# Access Compliance Report

## Public Rights-of-Way

Intersection ID: 54365	Main Street: GANNON_DR	Cross Street: COLLINS_FORD_RD	Location: SE
ADA ID: 25EEC4E05A42	Ramp Type: BlendTrans1	Initial Pass/Fail: Fail	Overall Compliance: No
Severity Score: 1.25			
Codes/Mitigation Info/Possible Solution		Field Measurements/Component Compliance

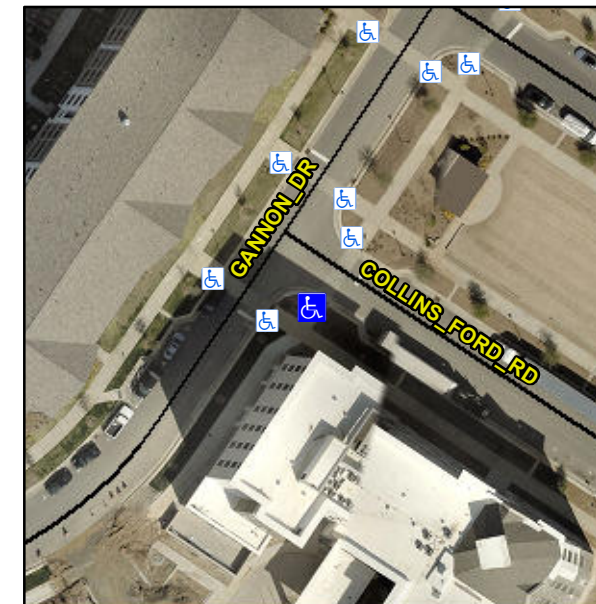
**XWALK PAVERS**

**Not Found, R304.5.3**

**Remove & Replace Curb Ramp With Two New Directional Ramps or Equivalent.**
